**LuK Service Info**

**Part Nr. 333 0193 10 – 330 TDCN**

Manufacturer: LANDINI

**TB1535**

Art.-Nr.: 333 0193 10

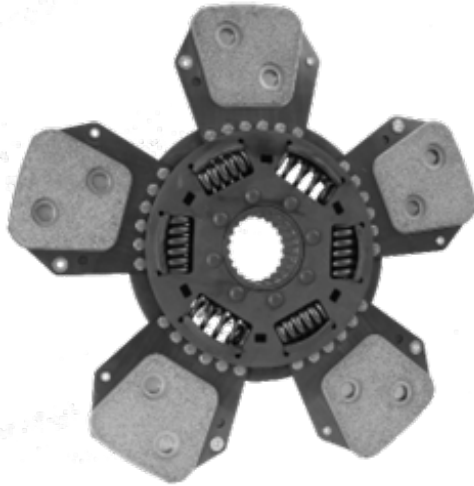
Info: 633 3039 09 replaces / ersetzt / remplace / sustituye a / sostituisce 333 0193 10

**333 0193 10**  
**3657 987 M91**

**633 3039 09**  
**3559 828 M91**
